Review of Operating Techniques and Permit Conditions – Pembroke Power Station

January 2020

Appendix C. Contaminant Source - Bulk Storage Tank Locations

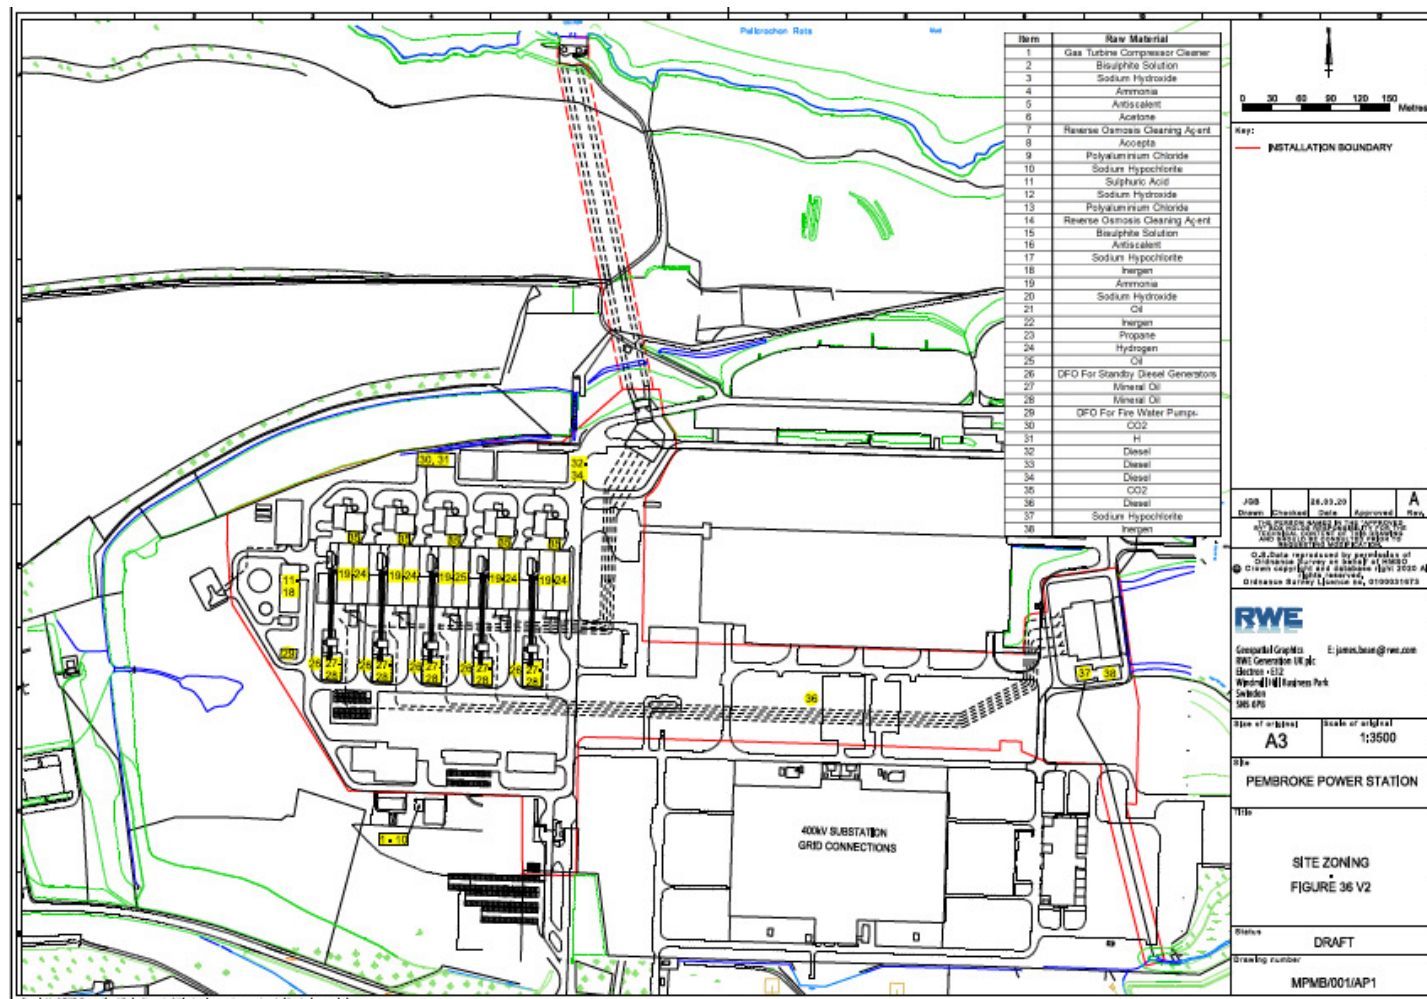
A thorough investigation took place into all contaminant source bulk storage on site. Since construction new chemical and diesel storage areas have been put in place. This is reflected in the updated versions of tables 3.4 to 3.8b that can be found in Appendix B. New numbers have been assigned to the tables due to new storage areas and new individual numbers have been assigned to the specific descriptions of contaminants stored. To compliment this, Figure 36, Contaminant Source Bulk Storage Locations (Appendix B) has also been updated.

Since construction some new storage areas for hazardous materials have been put in place. These areas have been updated on the relevant map and new tables have been produced. If new hazardous materials or storage areas are constructed they will be added when they occur.
